**From: Timothy J. Thompson, P.G., Principal Geologist**

**Subject: Review of Supplemental Data Geologic Hazards Evaluation AJ Rock LLC Property  
6695 South Wasatch Boulevard Cottonwood Heights, Utah (October 4, 2020)**

**Review of Geologic Hazards Evaluation AJ Rock LLC Property  
6695 South Wasatch Boulevard Cottonwood Heights, Utah (May 11, 2020)**

**Review of Surface Fault Rupture Hazard Evaluation AJ Rock LLC Property  
6695 South Wasatch Boulevard Cottonwood Heights, Utah (October 8, 2018)**

**Figure 15.** Fault trench length and orientation to investigate a building footprint. Trenching must extend beyond the footprint of at least the expected setback distance for the IBC Building Risk Category class (from Christenson and others, 2003).

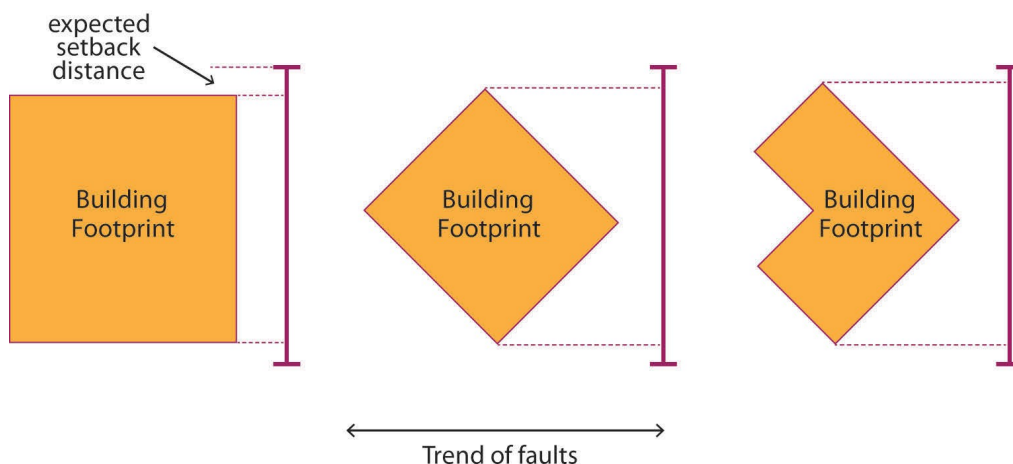
Western Geologic recommends the Project civil engineer should review the fault setbacks presented on Figure 4 on a case-by-case basis to ensure that structures are setback a safe distance from active faults in areas where significant cuts are planned. Western Geologic also states that it is their understanding that minor adjustments will be made with regard to the condominium and Pad E structures on Figure 4. They recommend that the most-recent grading plan be submitted to Cottonwood Heights City at the time their report and the geotechnical engineering report are submitted to the city, but they state that the site plans may change and may differ from the base provided on Figure 4. GeoStrata recommends that Cottonwood Heights City require the applicant to allow Western Geologic to review the final design site plans and make any necessary comments on the grading plan and adjustments to their recommended fault setbacks. We further recommend that Cottonwood Heights City require the applicant to allow Western Geologic to perform a final surface fault rupture hazard assessment of each proposed structure on a case-by-case basis to assess each proposed buildable area for active faults and make any necessary modifications to their surface fault rupture hazard mitigation recommendations. We recommend that Western Geologic perform the final surface fault rupture hazard assessment of each proposed structure once final grading plans and design plans have been prepared and prior to final approval of the development plans by Cottonwood Heights City.

It should be noted that the setback areas as shown on Figure 4 are delineated around the mapped locations of the surface rupture faults as shown on Figure 4. In Bowman and Lund (2016) Chapter 3 Guidelines for Evaluating Surface-Fault-Rupture Hazards in Utah, under the section heading Fault Mapping, subsection heading Trench Number and Location (page 44) it states: “...Trenches should be oriented perpendicular, or as close to perpendicular as possible, to the trend of the mapped fault trace at or near the site, and be of adequate length to intercept faults projecting toward proposed or existing structures and potential setback areas....”

Based on the recommended practice as described by Bowman and Lund (2016), trenching must extend beyond the proposed footprint of planned structures at least the distance of the expected or calculated setback distance. This means that the setback areas as shown on Western Geologic’s Figure 4 should extend in from the ends of the trenches into the trench the distance of the calculated setback distance. The boundaries of the setback areas and buildable area as shown on Western Geologic’s Figure 4 should be determined considering the UGS recommendation that trenching must extend beyond the footprint of each proposed structure a distance of at least the expected setback distance for the IBC Building Risk Category class (from Christenson and others, 2003) as shown above on the Bowman and Lund (2016) Figure 15. Setback areas and buildable areas for each proposed structure should be established in accordance with the method described by Bowman and Lund (2016) as part of the final surface fault rupture hazard assessment of each proposed structure. We recommend that the Cottonwood Heights City require Western Geologic to delineate surface fault rupture setback areas and buildable areas for the subject site on an updated Figure 4 in accordance with the method described by Bowman and Lund (2016).
